TOWN OF NISKAYUNA
Planning Board and Zoning Commission
Agenda
February 13, 2023 7:00 PM

TOWN OF NISKAYUNA
Planning and Zoning Commission
Hybrid Meeting
Meeting Minutes
December 12, 2022

TOWN OF NISKAYUNA
Planning and Zoning Commission
Hybrid Meeting
Meeting Minutes
January 9, 2023

Drawing
Reference
Number:
C-1

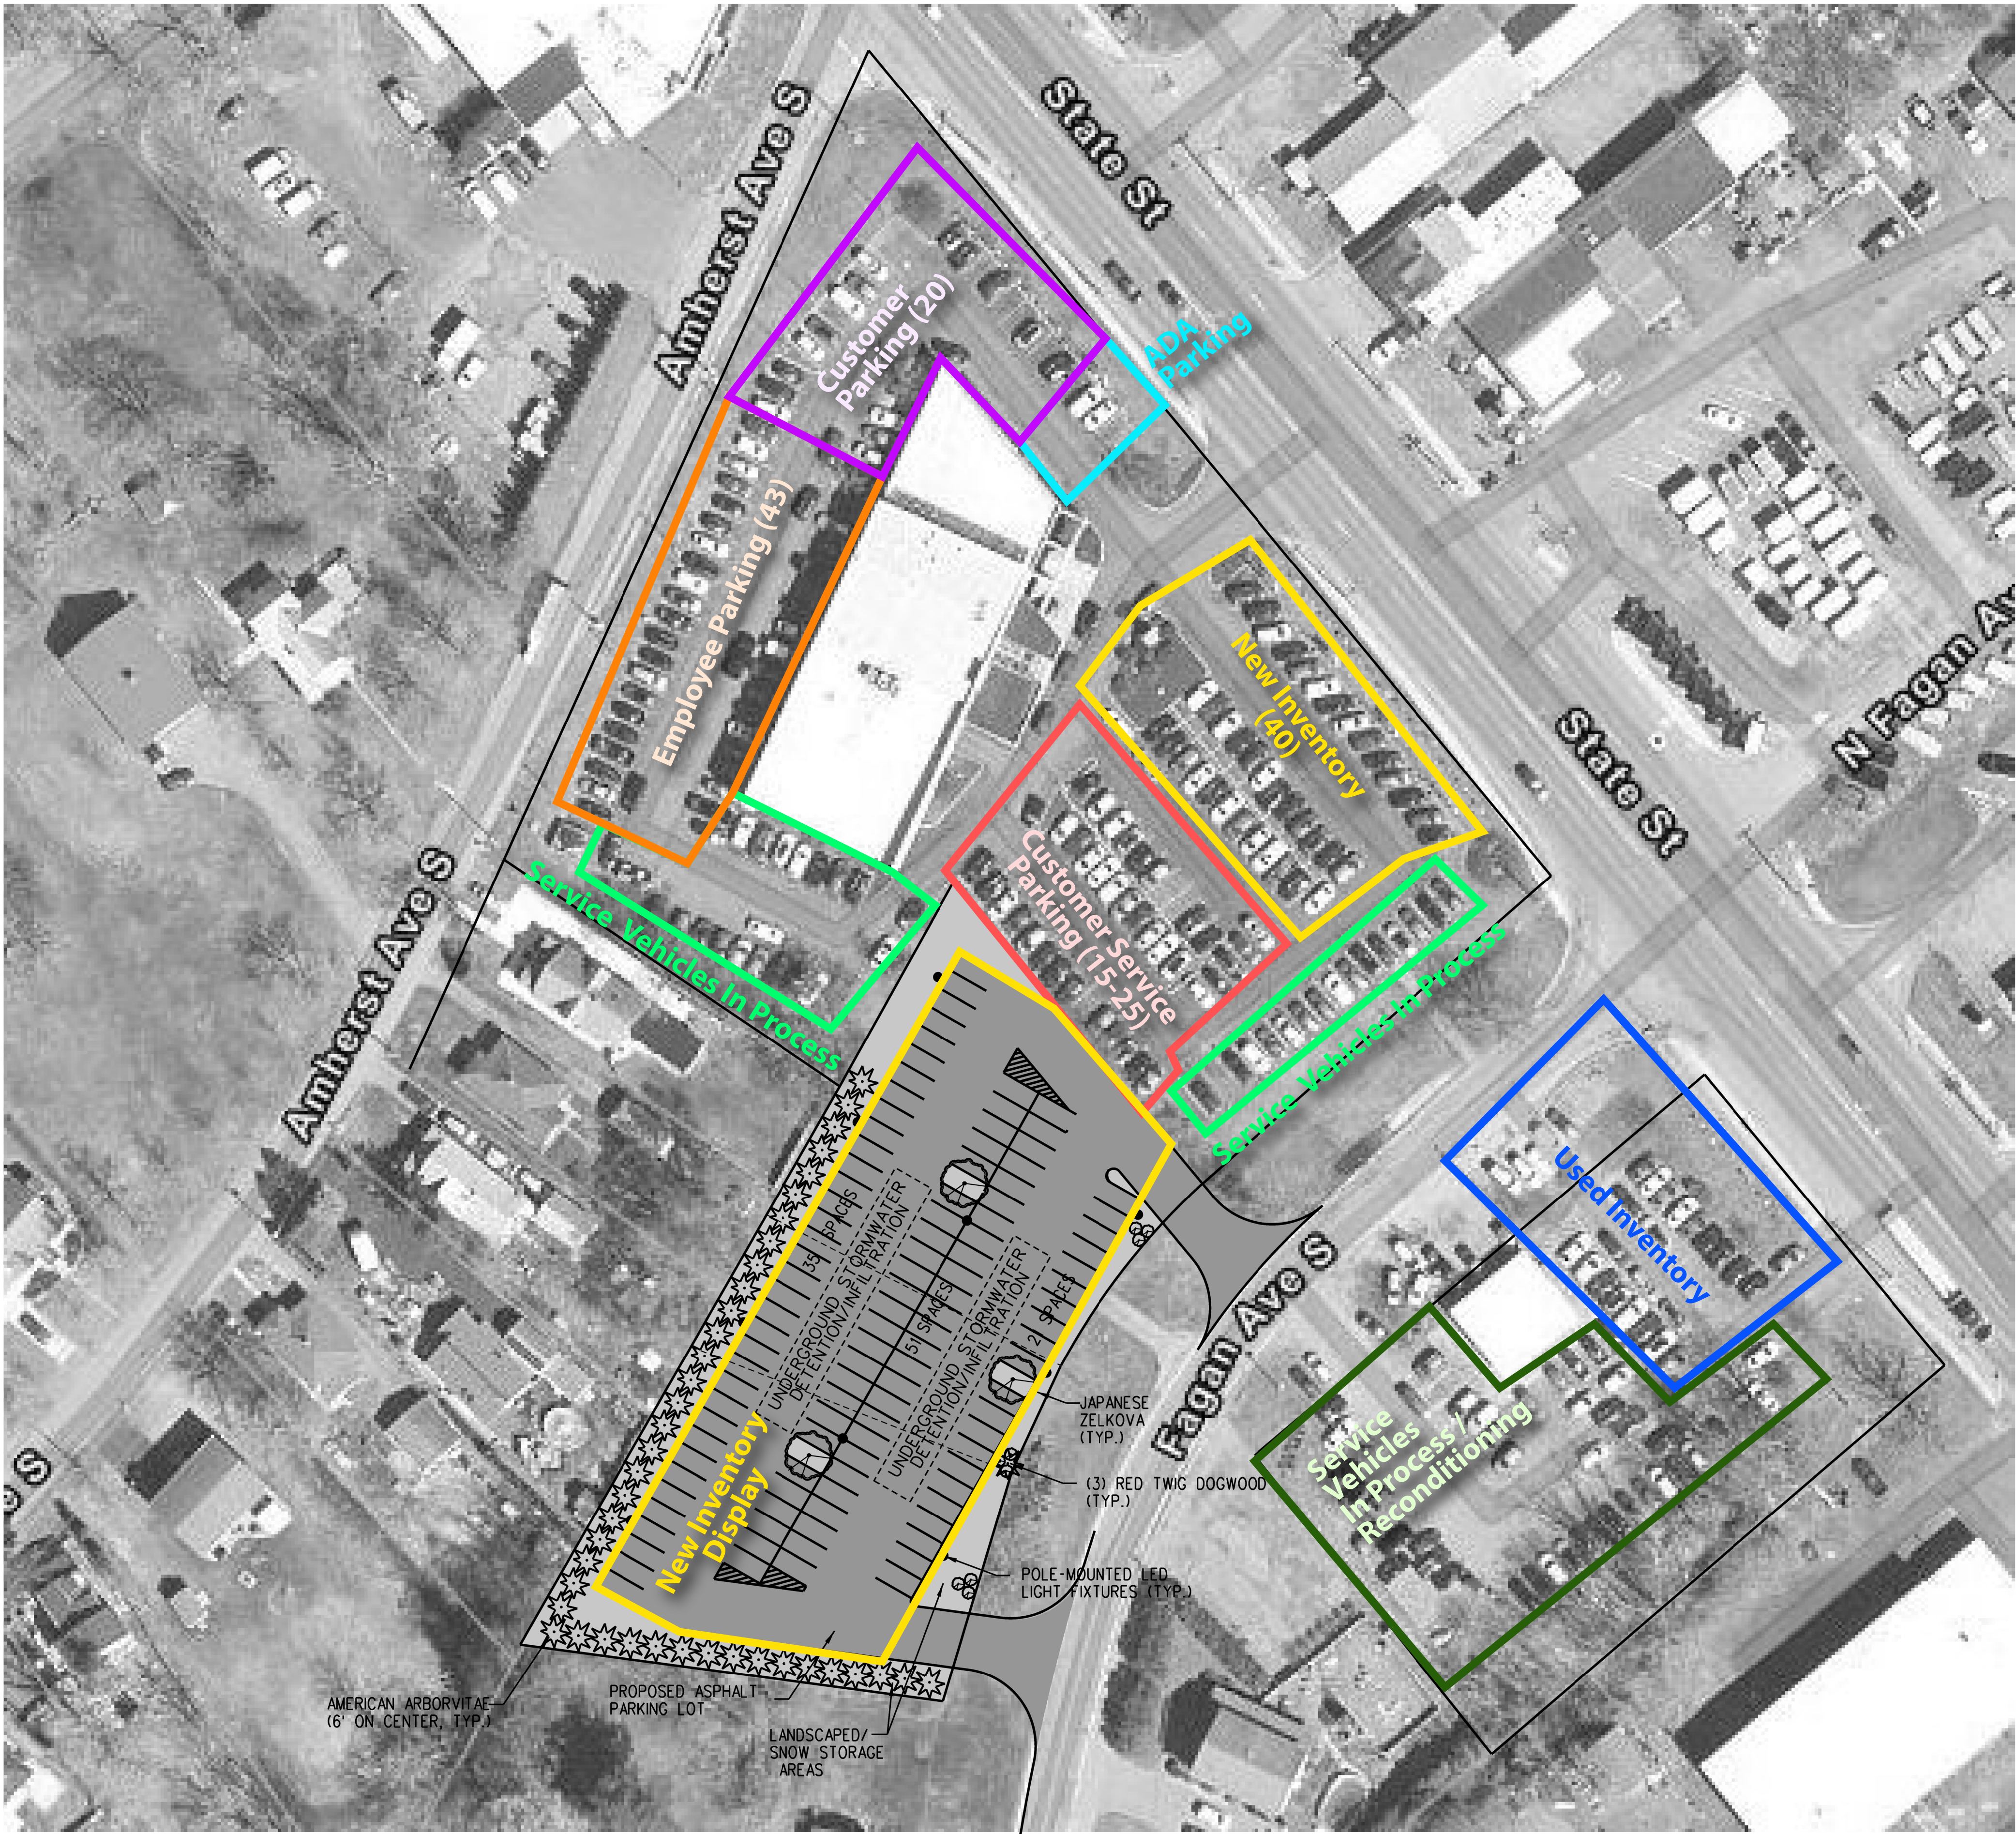
153 Reading comments from the Conservation Advisory Council, Chairman Walsh detailed concerns
154 over removal of green space as well as seemingly underutilized areas owned by the same group
155 across the street on Fagan Ave. Chairman Walsh asked if this could be an opportunity to enhance
156 the already owned space across the street. Mr. Salvagni spoke briefly on future plans to enhance
157 the aforementioned lot; however those plans still included the site plan proposal in question. Mr.
158 Salvagni said the proposed lot could be used as a show lot as well as potentially a storage lot for
159 the adjacent Kia dealership. When prompted by Chairman Walsh, Mr. Salvagni said the lot
160 would have to be lit for security reasons, however, he assured the Board that there would be
161 ample buffering to avoid light pollution.

162
163 Mr. Khan inquired about customer parking on the lot, to which Mr. Salvagni responded that was
164 not in the plans. Mr. Khan then asked about the primary driver for the lot. Mr. Salvagni stated
165 that customer sales parking as well as customer service parking were two key factors that would
166 be bettered by this lot. He re-iterated that customer sales and service parking will occur solely on
167 the existing lot, with the proposed lot being set aside as a show and storage lot.

168
169 Chairman Walsh confirmed with Mr. Salvagni that there are three properties involved in this
170 project, and in total will yield 144 spaces for the dealership. Mr. Skrebutenas asked if the
171 applicant had looked into 4002 State St. which lays on the other end of S Fagan Ave entrance.
172 Mr. Salvagni explained that lot is already purchased and utilized by the dealership as a
173 reconditioning center. Mr. Salvagni expressed desire to reconfigure the 4002 lot; however, he
174 emphasized that doing so will still not mitigate the need for the project in question. When asked
175 about the Hyundai dealership owned across the street by the same owner, Mr. Salvagni stated
176 that lot has also reached its capacity and could not support the Kia dealership. Mr. Salvagni also
177 stated that this fix is not a long term solution, and more space will need to be found in the future
178 to remedy their parking issue.

1/27/23 Complete Streets Committee (NCSC) meeting – The Complete Streets Committee reviewed the most recent site plan drawing and requested that the project include the addition of a new sidewalk along Fagan Ave from State St. to Albany St.

Proposed Driveway Revised - 1/20/23
Tape Added - 1/18/23
Revised - 12/5/22
Revised - 11/5/22

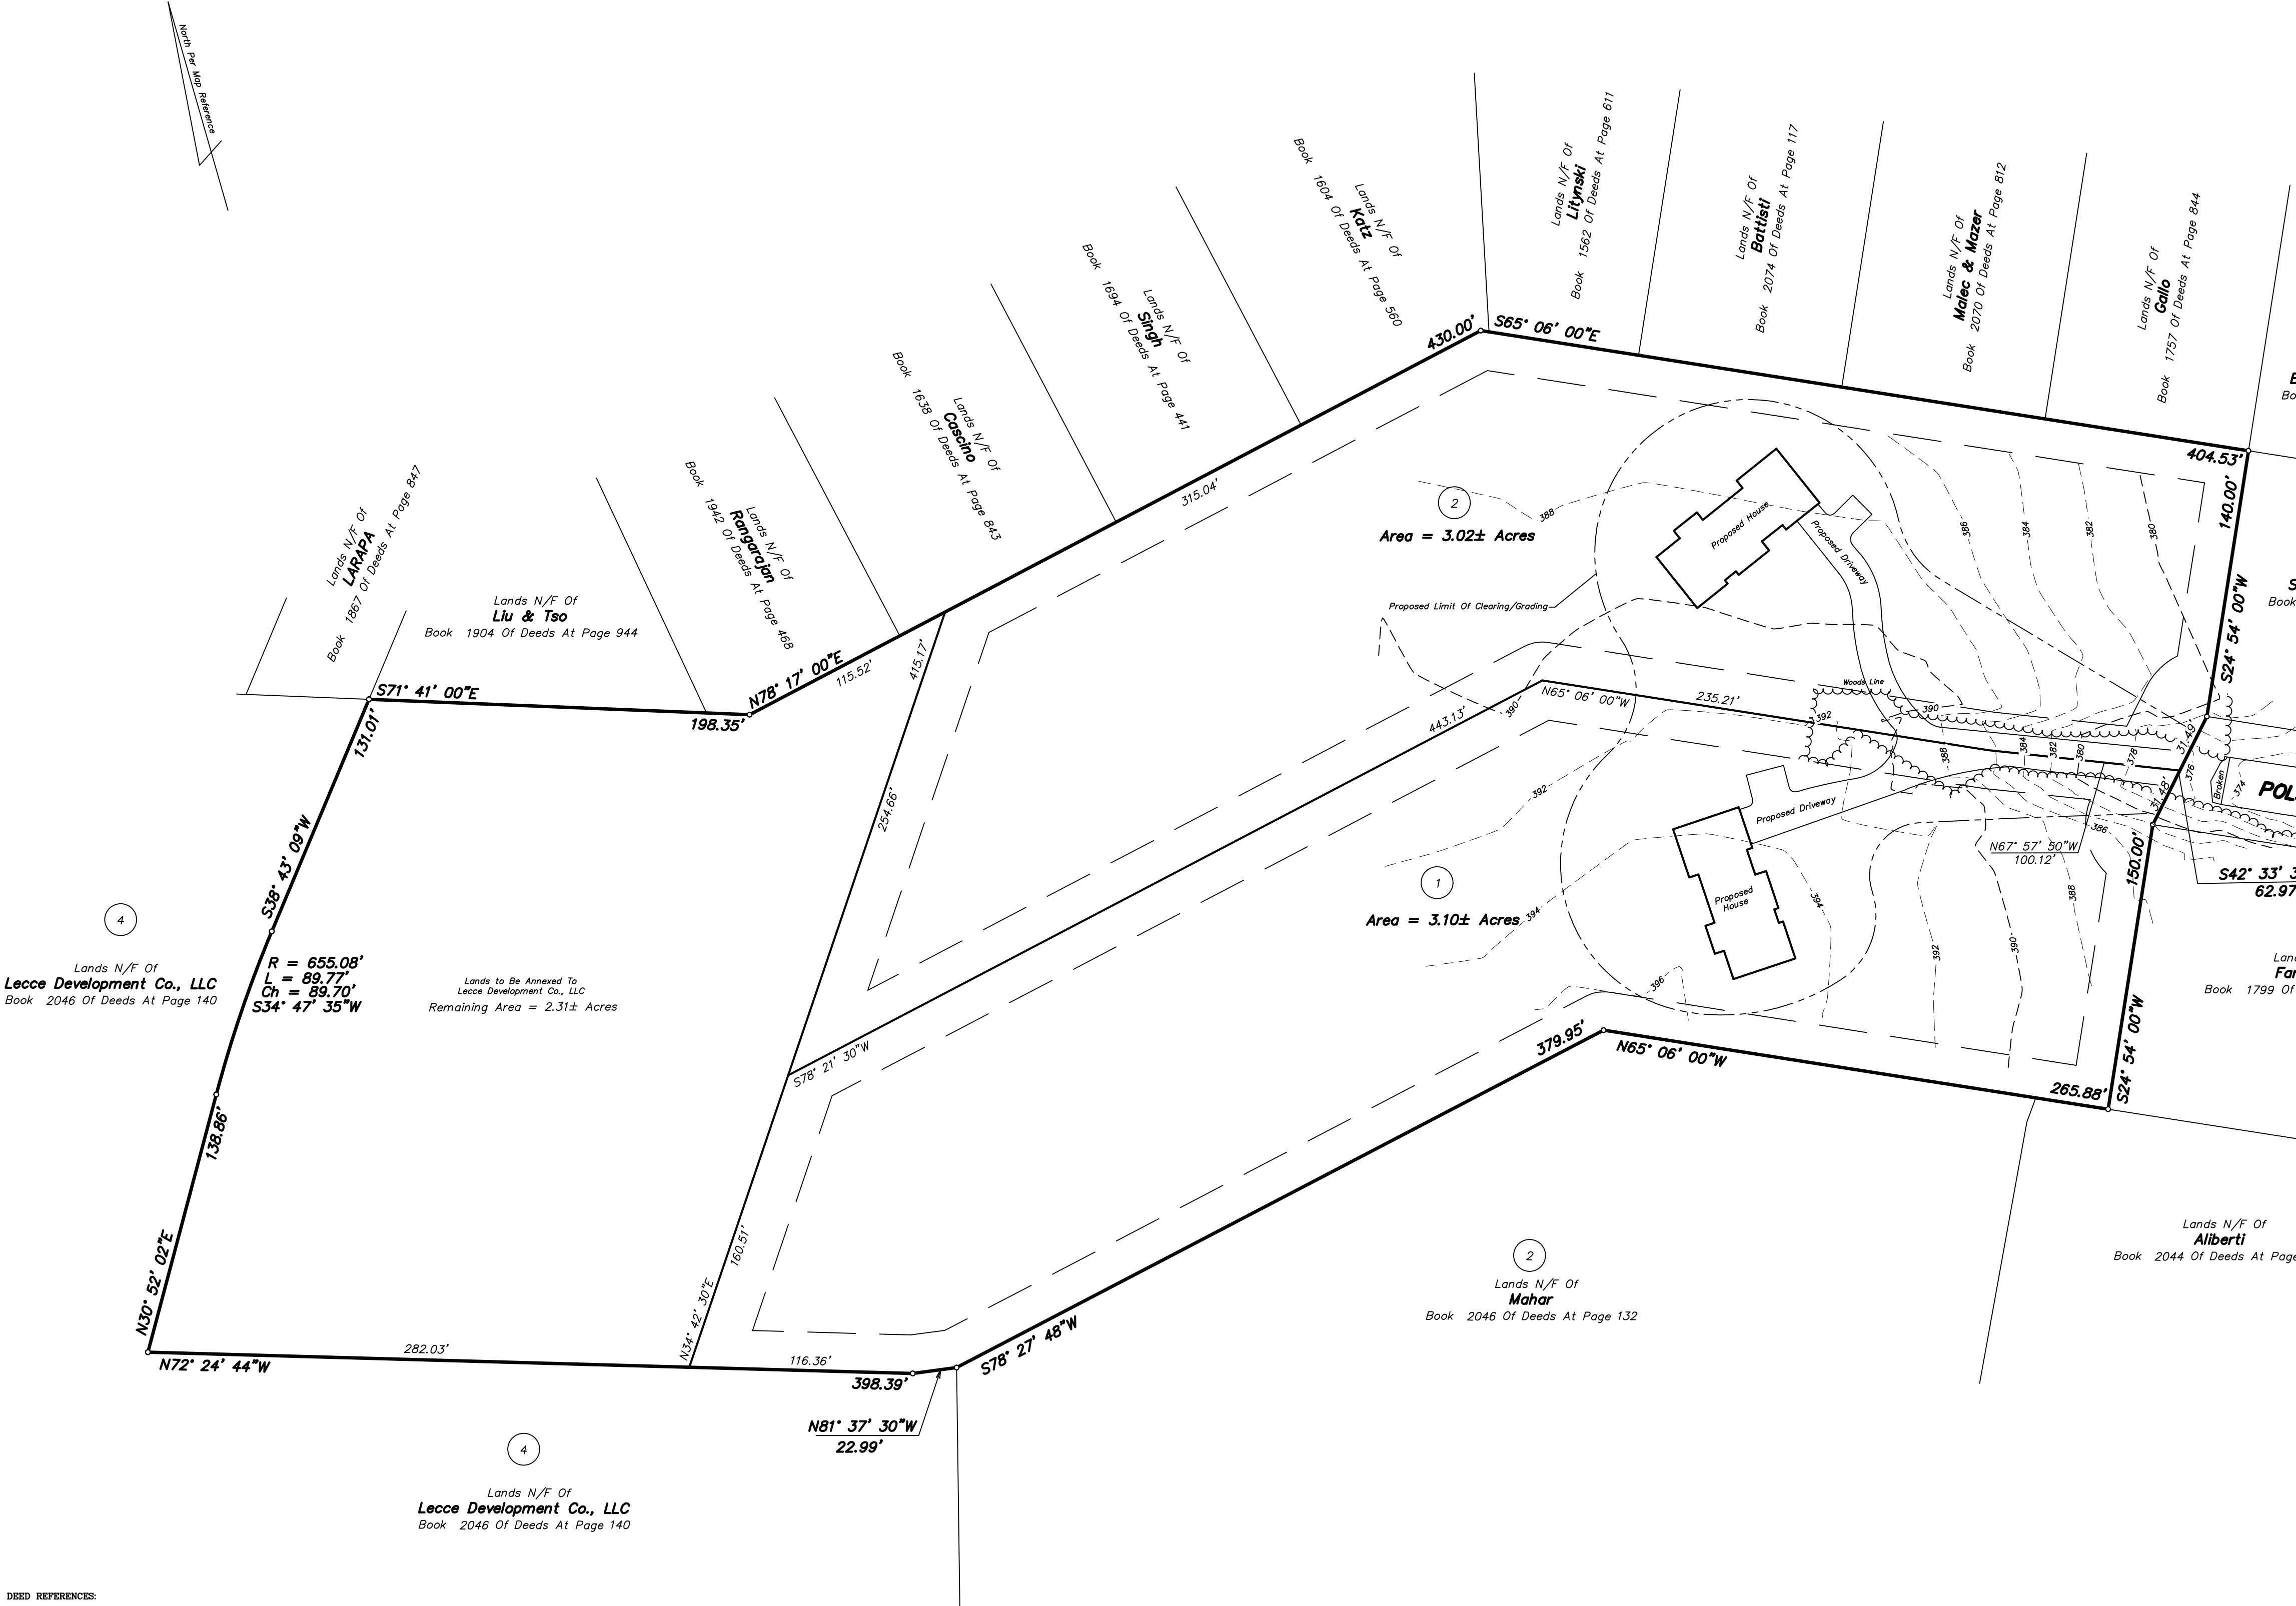
| No. | Description of Request | Status |
|-----|--------------------------------------|--|
| 4 | Include wetland delineation | Wetlands are shown in the back lot but a reference note indicates the delineation is from a survey performed in 2006. A more recent survey is appropriate. |

The PB should review & discuss the new 6-page drawing set with the applicant.
